**Re: Lee County Resource Recovery Facility (LCRRF), PA90-30H
Post Certification Amendment
WACS Facility ID: 93715**

The Lee County Solid Waste Department requests approval of a post-certification amendment to the Conditions of Certification (PA90-30H) for the Lee County Solid Waste Energy Recovery Facility (SWERF). The following three (3) enhancements are necessary to support the existing facility and are provided in a general site plan in Attachment I.

Attachment I- General Site Plan

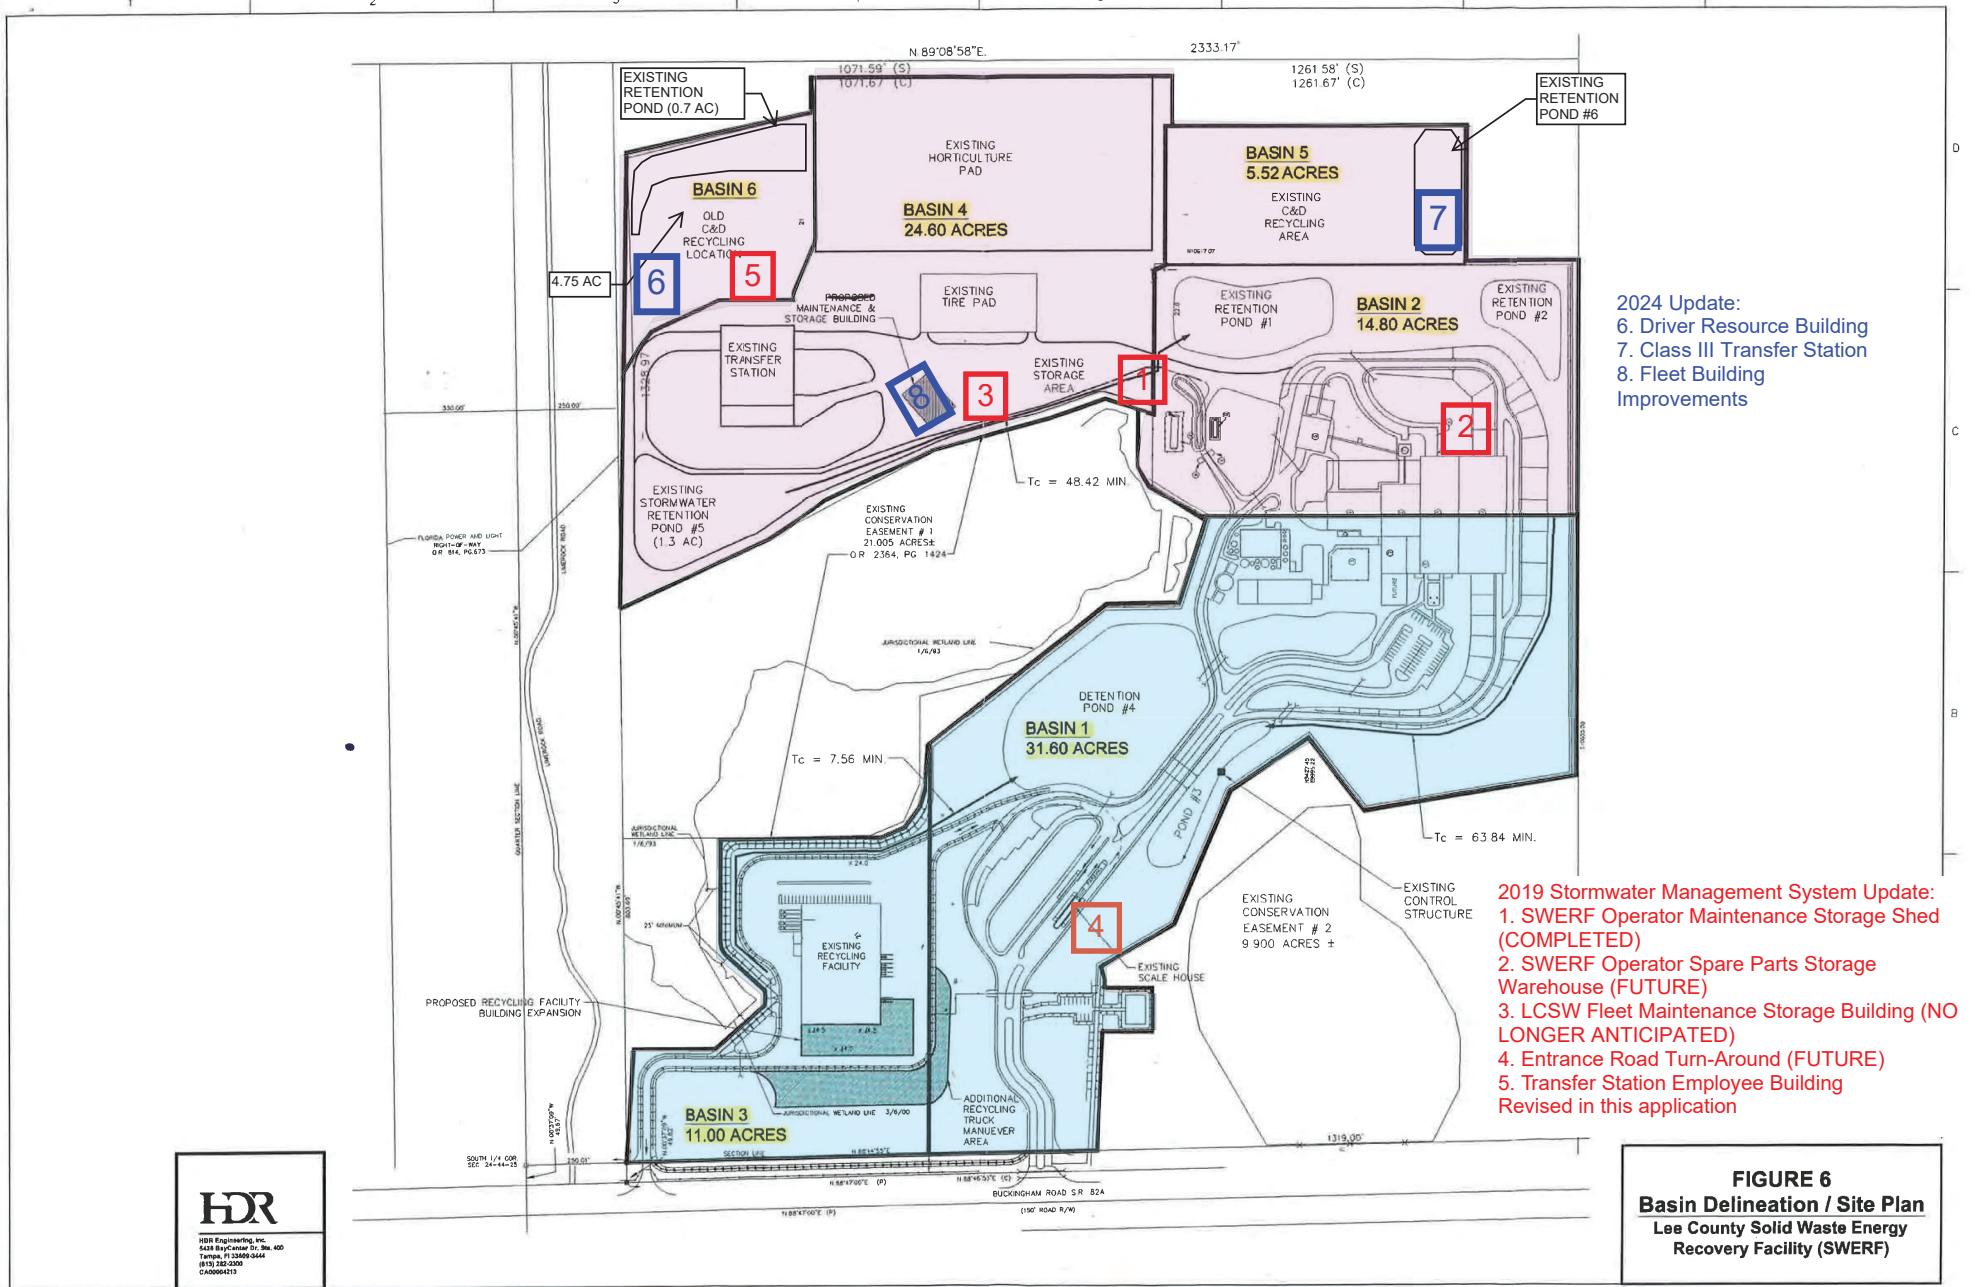
1. Employee Resource Building (Attachment II)- A Transfer Station Employee Building was proposed and approved in a post certification amendment in 2019. This building was never constructed, and the location has been revised. The newly proposed Employee Resource Building with associated parking lot improvements, has a similar footprint, and is in the same stormwater basin. The building will include a resource center, locker rooms, training room, kitchen, bathrooms and showers, and break room for the increased staff necessary to support Waste to Energy operations.

Figure 1: Preliminary Berm Design

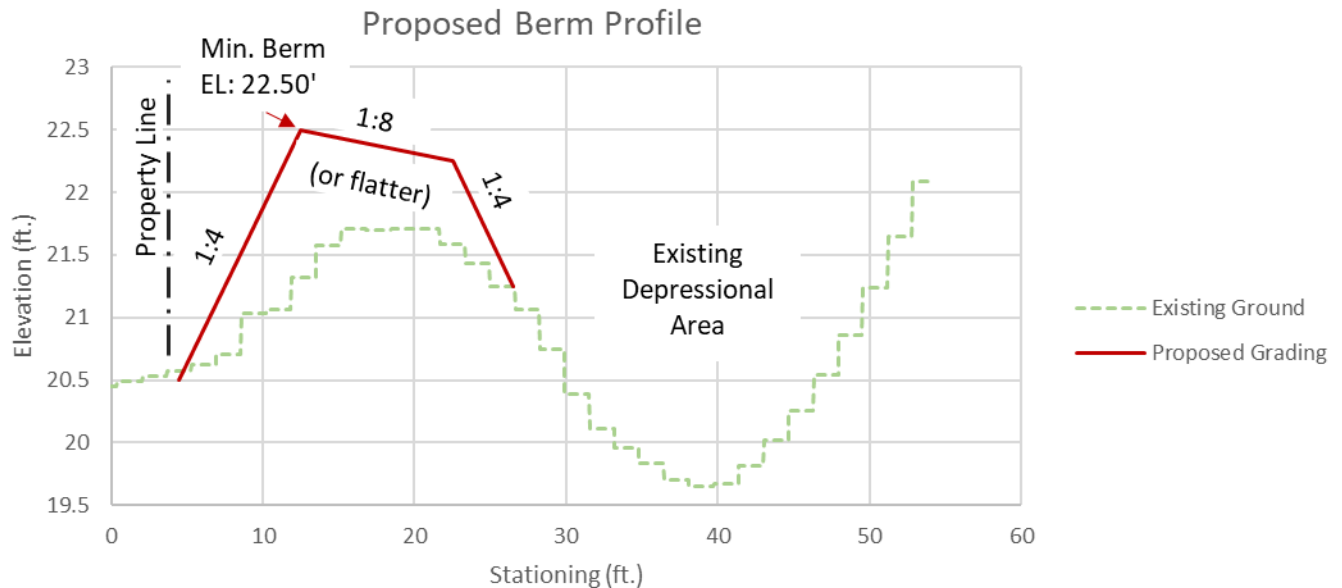
Using the results of the proposed conditions analysis, it was determined that a minimum berm elevation of 22.27-ft would be required to contain the 100-year, 72-hour design storm event and prevent off-site flows or impacts to the master stormwater plan of the site. It is recommended

that a **minimum berm elevation of 22.50-ft** be used for design purposes, which provides 3-inches of freeboard and accounts for some uncertainties in the analysis.

A preliminary berm design is provided below in Figure 1.

PROPOSED DRAINAGE MAP
Figure 2

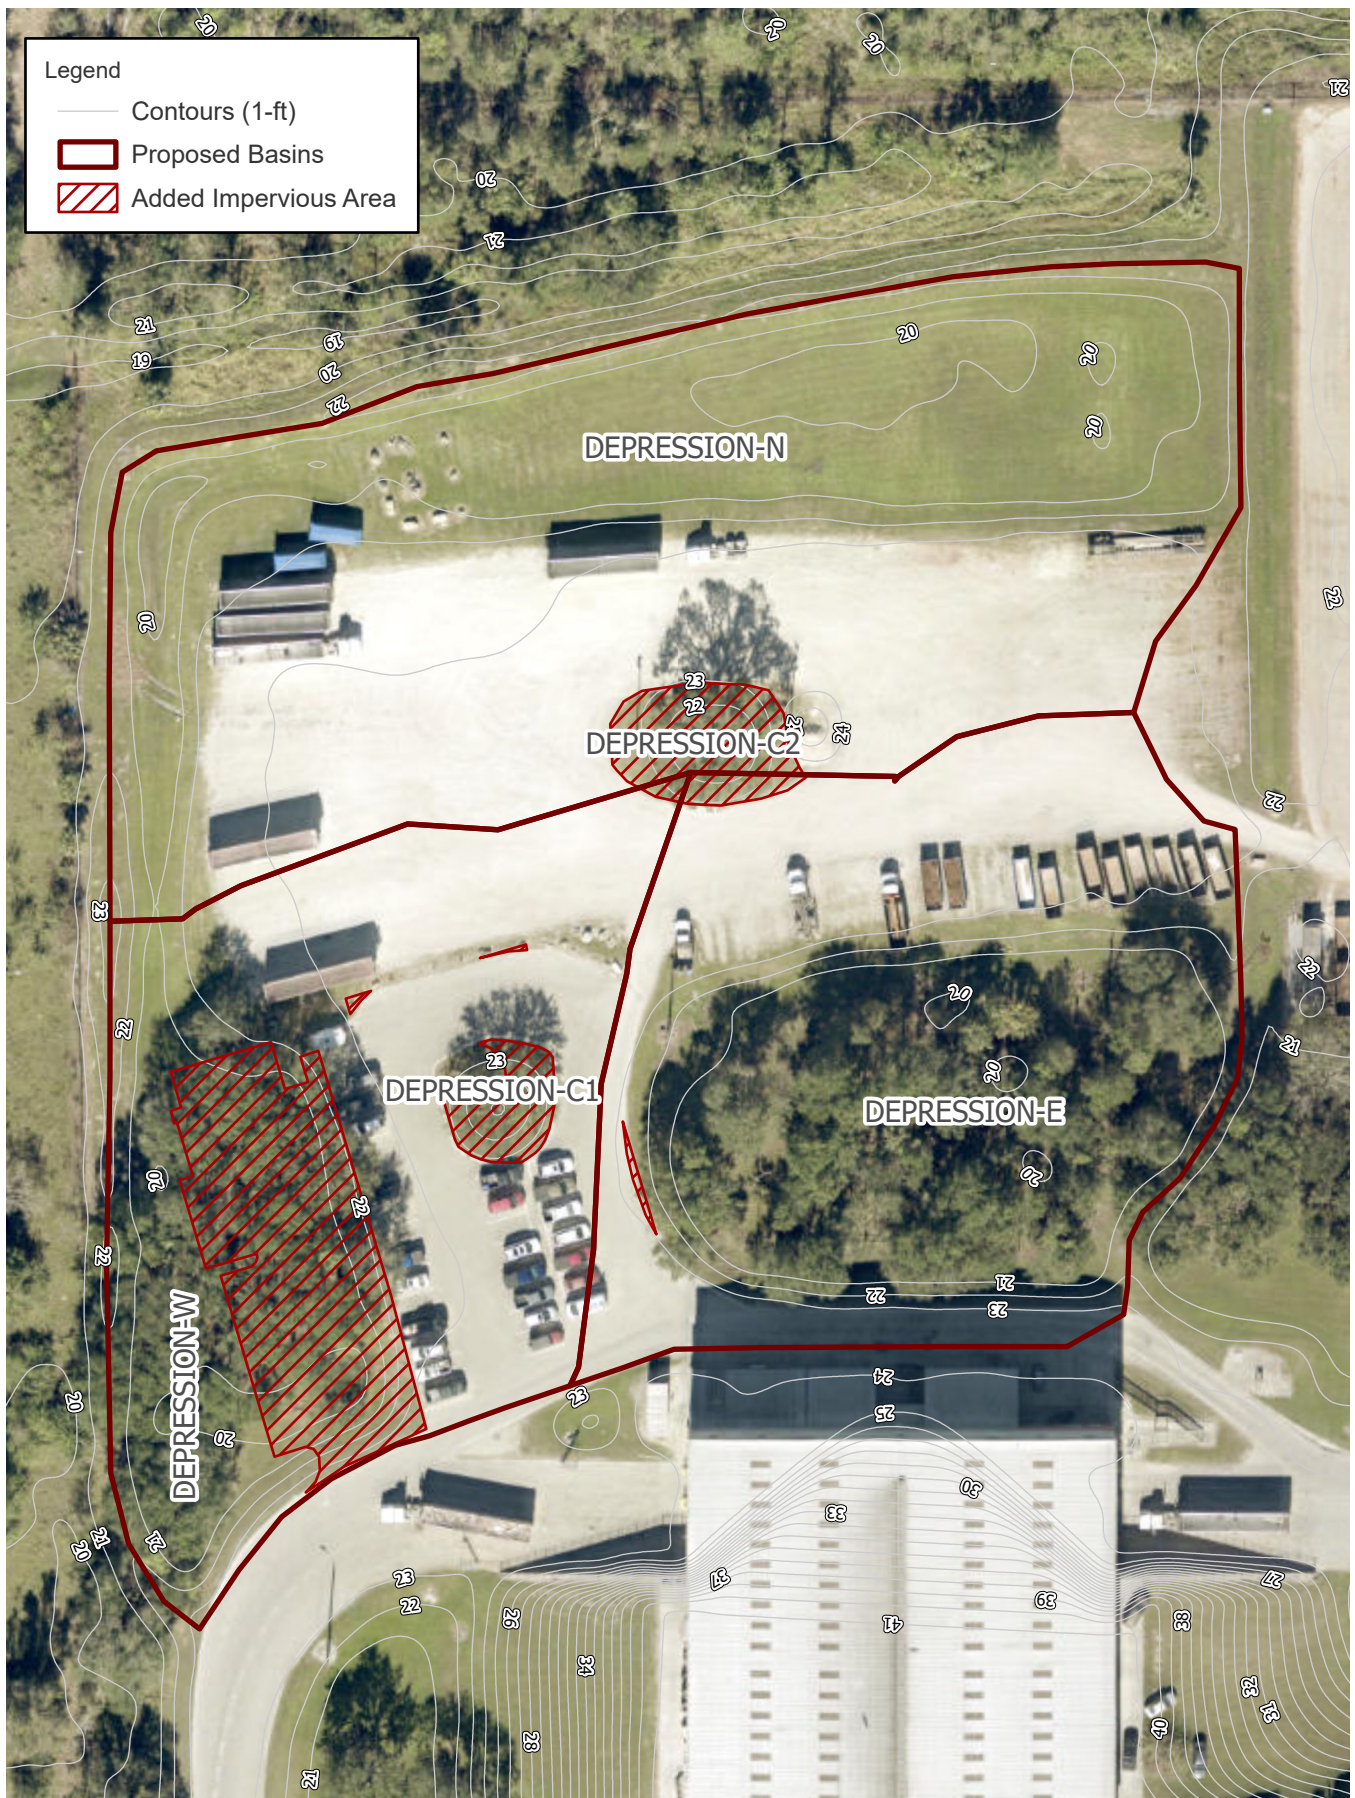
A proposed condition model was developed from this existing condition model to represent the proposed site development. Storage around the proposed parking lot and building locations was removed from the nodes to represent the fill that would be added to the site. Proposed land usages, including the impervious building footprint and expansion of the paved parking lot, were drawn from a preliminary site layout provided by the County. The results of these analyses are presented below in Tables 1 and 2.

The results of the analysis show that all runoff from a 100-year, 72-hour design storm event is contained within Basin 6 in the existing condition; however, the proposed improvements raise peak stages above the existing berm elevations, causing off-site discharges. After discussion with the County, it was determined that a preliminary design involving elevating of the existing berm would be analyzed to determine if the project was still feasible.

Facility E - Construction and Demolition Debris Recycling Facility
Buckingham Solid Waste Resource Recovery Facility
Lee County, Florida

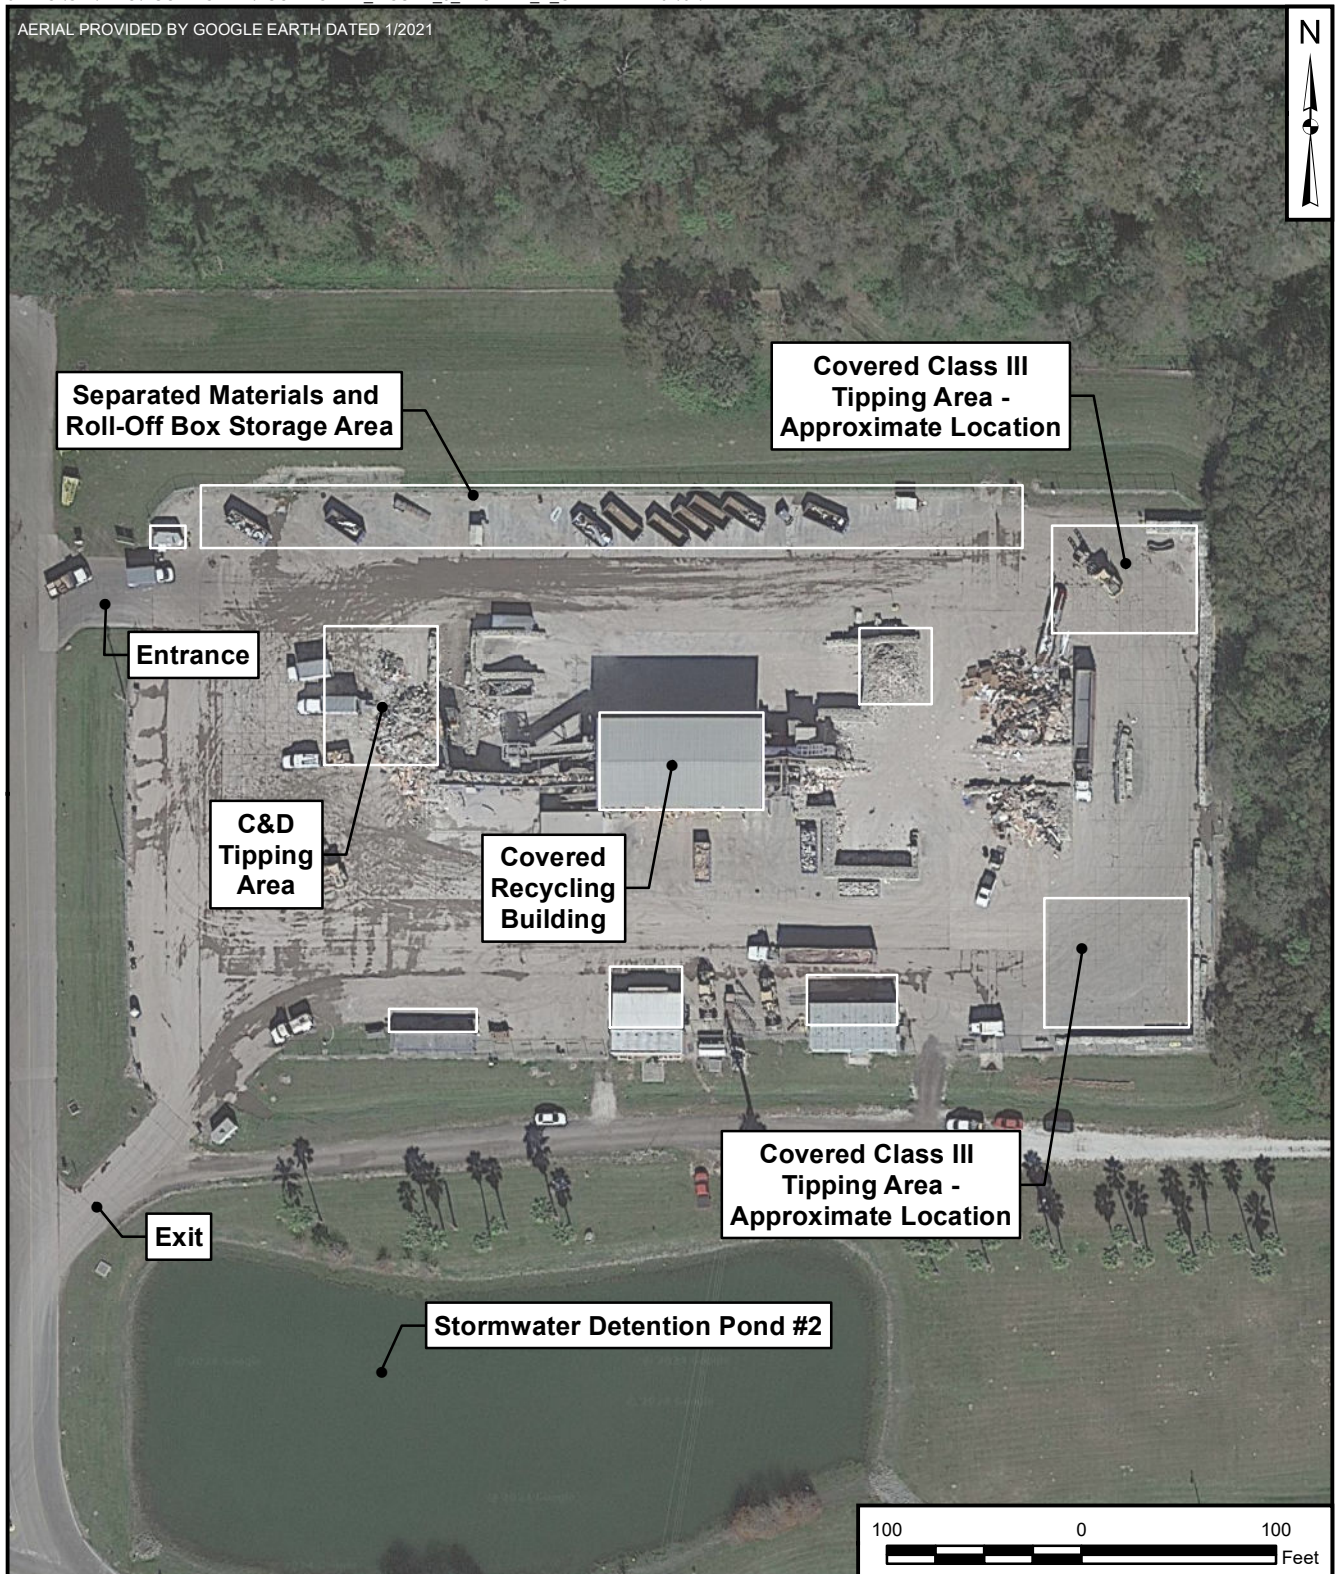
One covered Class III tipping area at the southeast end of the CDDRF is shown on the Site Plan in Appendix B. The tipping area consists of concrete bin blocks with dimensions of 3-feet by 3-feet and measuring 6-feet in length. The tipping area will have interior dimensions of 54 feet in length, 42 feet in width, and 9 feet in height, with the open wall on the west side. A second tipping area at the northeast end of the CDDRF, consisting of concrete bin blocks of the same dimensions, may be covered and accept Class III waste if need arises. This northern tipping
